KUNDRATHUR PANCHAYAT UNION
LAYOUT OF HOUSE SITES IN S.No: 17 / 1B2 OF VARADHARAJAPURAM VILLAGE.
 SCALE : 1:800 (ALL MEASUREMENTS ARE IN METRE)

P.P.D NO : 176
L.O : 2024

APPROVED
VIDE LETTER NO : LAYOUT-1 / 0125 / 2024
DATE : 09/08 / 2024

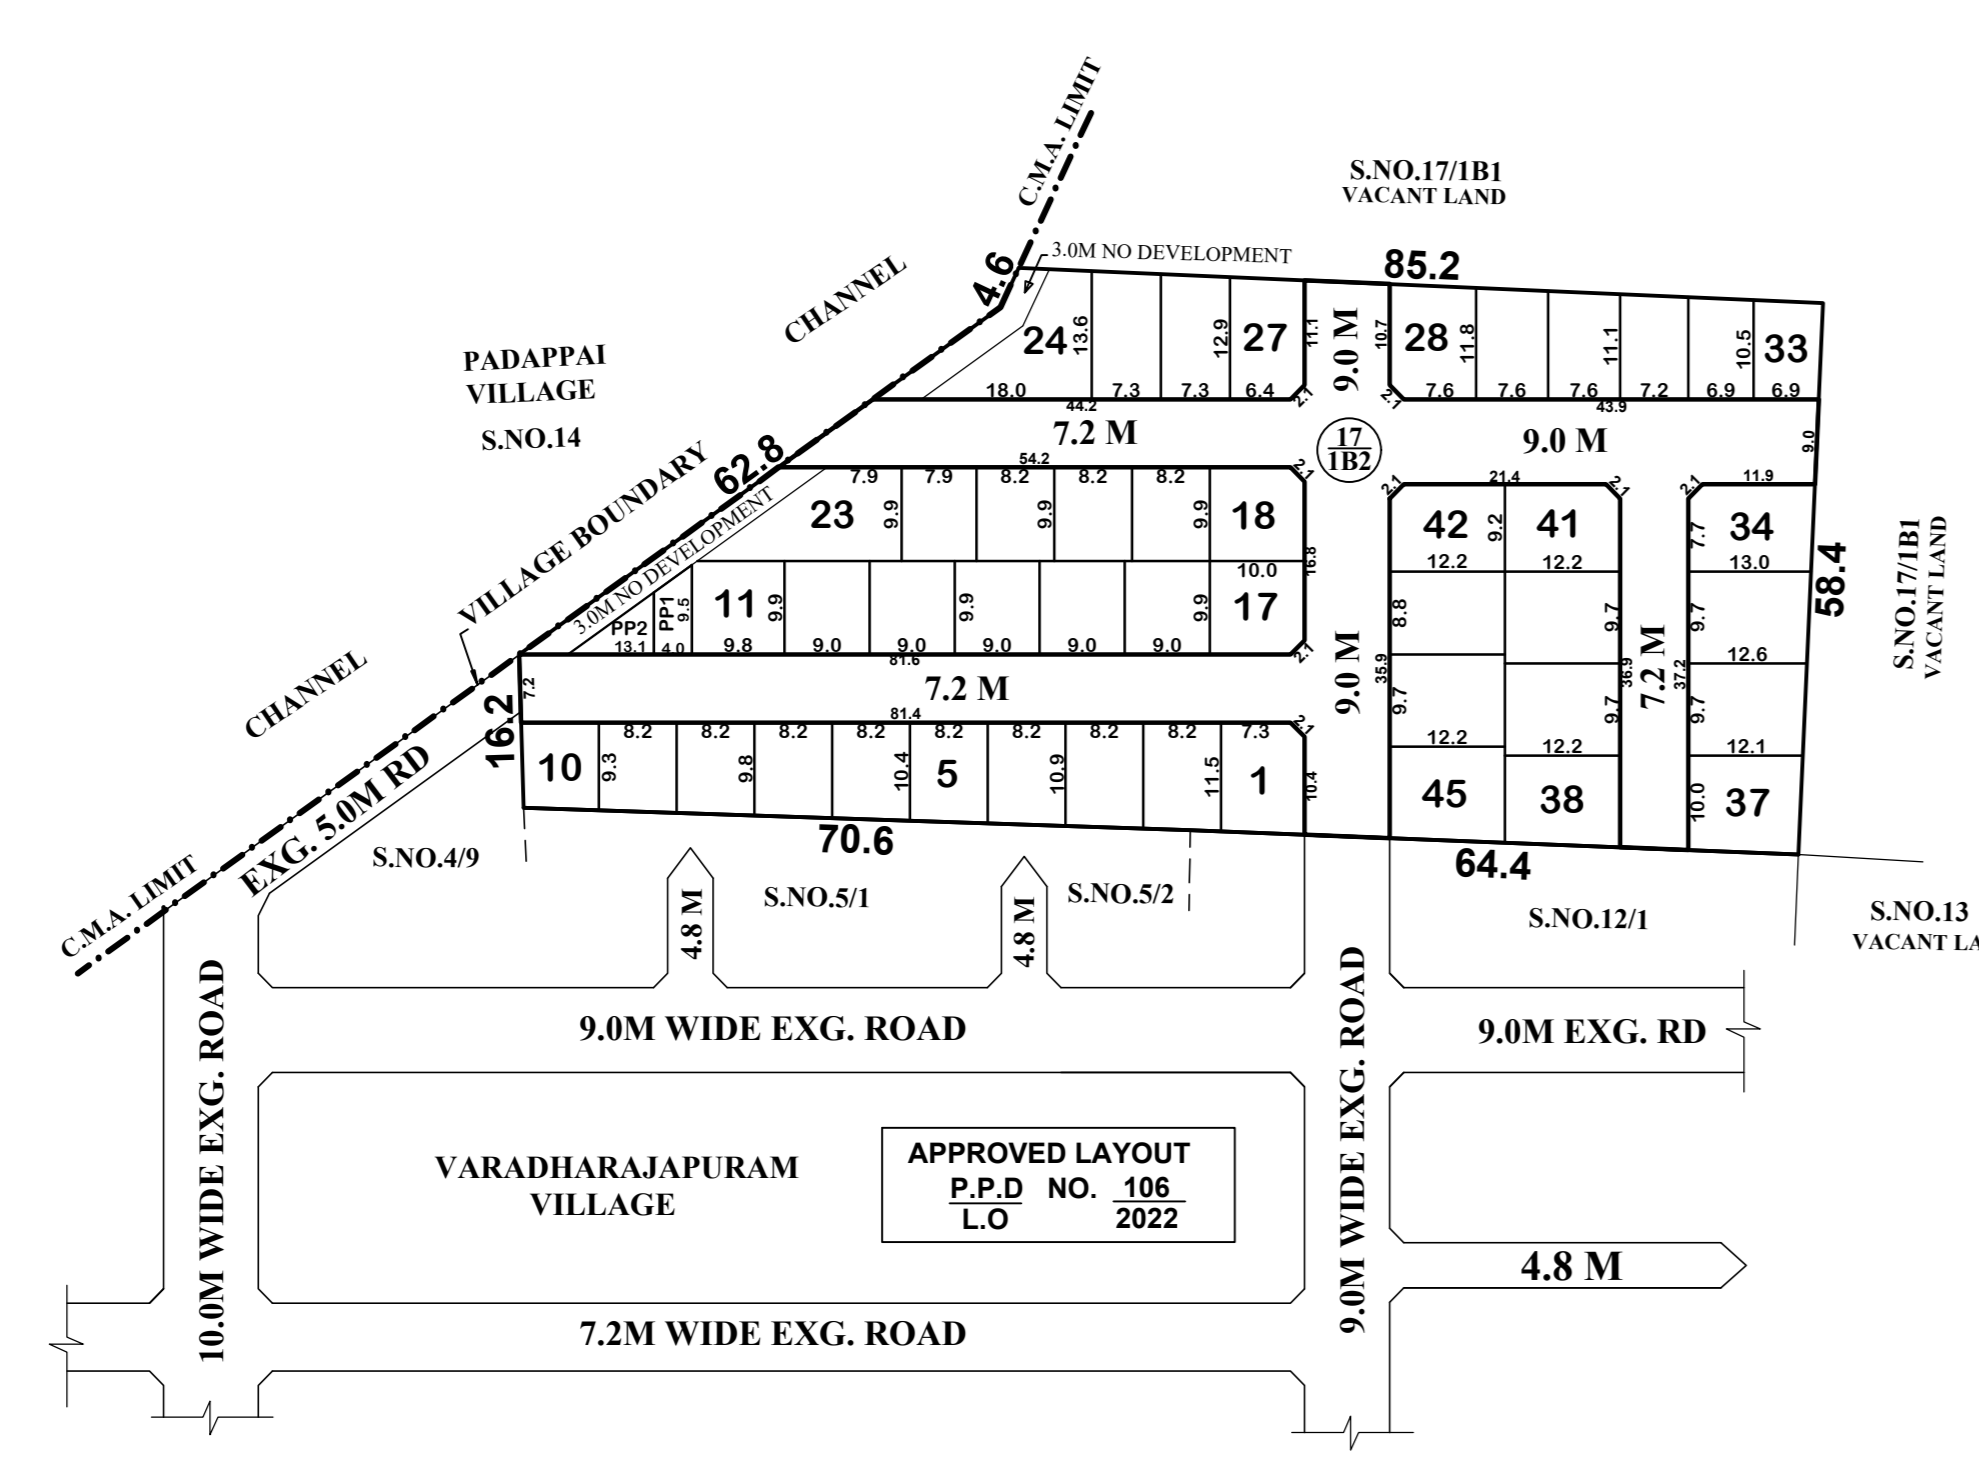
(i) THE APPLICANT SHOULD FOLLOW THE CONDITIONS MENTIONED BY THE CE, PWD, WRD, CHENNAI REGION, CHEPAUK, CHENNAI -S, LETTER NO.DB/TS(3)3999/F-NOC VARADHARAJAPURAM VILLAGE 4989/2023/DATED:26.06.2024 ARE TO BE COMPLIED BY THE APPLICANT BEFORE ISSUING OF THE LAYOUT APPROVAL BY THE COMPETENT AUTHORITY (LOCAL BODY)

- The applicants' land should be filled with earth filling with proper Compaction to the minimum level of (+) 20.250 (i.e.) 2.050m above the Inlet Skuice of the Mannivakkam Tributary of Adayar River level as (+)18.200m to protect the site from inundation during floods. The process of earth filling and compaction should be done in layers of not more than 0.30metre depth to achieve required degree of compaction for the depth from (+)1.570m to (+)1.620m depending upon the existing field levels. Also, the applicants should provide emergency pumping operation for the sewage water, if it is proposed to have basement floor and as well as dewatering arrangements during flood periods. The all-round pavement level within the site should not be less than (+)20.250m and the regular habitation should not be below MFL.

- The Orathur Tributary (Government Maduvu) of Adyar River in Varadharajapuram village abutting on Western side of the applicant land should be completely de-silted and re-sectioned by constructing retaining wall on either sides of the channel with concrete bed as per the FMB at the applicant's own cost. The bed level of the above channel should be ascertained and restored before commencing the development activity in the presence of the concerned WRD Executive Engineer. Moreover, the width of entire channel as per Revenue records (FMB) along and within the stretch of applicant's land should be maintained properly without any change and without encroachments.

- The Orathur Tributary (Government Maduvu) of Adayar River in Varadharajapuram village stretch abutting on Western side of the applicant boundary should be marked as per FMB and monitored and maintained by the applicant at his own cost. The width of the channel should be maintained without encroachments as per Revenue records and the hydraulic parameters of the field channel should be maintained. The applicant should make necessary periodical arrangements for free flow of water through the existing channel to the downside area within the proposed layout site. Also, the applicant should se-silt the channel periodically and remove the obstruction then and there without any hindrance or free flow of water at his cost within the proposed land, after the completion of project also.

- The applicants should prepare the layout proposal by considering the suitable internal storm water drainage network drain as micro drains i.e peripheral drain of suitable size not less than 1.20m x 0.90m & lateral drain of suitable sizes within the site as per the site condition. The same should be connected to the local drain / channel, rainwater harvesting, roads with road side drain and sewerage treatment plant and its disposal and garbages / debris and other solid waste management as per norms in existence within the applicant's land according to existing rules in force and should get proper approval from competent authority without fail.

- The necessary setback distance not less than 3.00m especially on Western side should be provided within the site as per site condition as per the norms in existence and as per the rules in force of CMDA (as per the circular issued by the office of the Commissioner of Town & Country Planning, Chennai - 2 vide Roc. No.4367 / 2019-BA2 / Dated: 13.03.2019) during development and there should not be any construction activities in future also, the CMDA should issue completion certificate only after obtaining compliance certificate NOC from WRD.

(ii) LOCAL BODY SHOULD ENSURE COMPLIANCE OF ALL THE CONDITIONS STIPULATE BY WRD, PWD IN THEIR LETTER NO.DB/TS(3)3999/F-NOC VARADHARAJAPURAM VILLAGE 4989/2023/DATED:26.06.2024, AND SHALL OBTAIN A LETTER FROM WRD CONFIRMING THE COMPLIANCE OF THE CONDITIONS BEFORE THE SANCTION AND RELEASE OF THE LAYOUT.
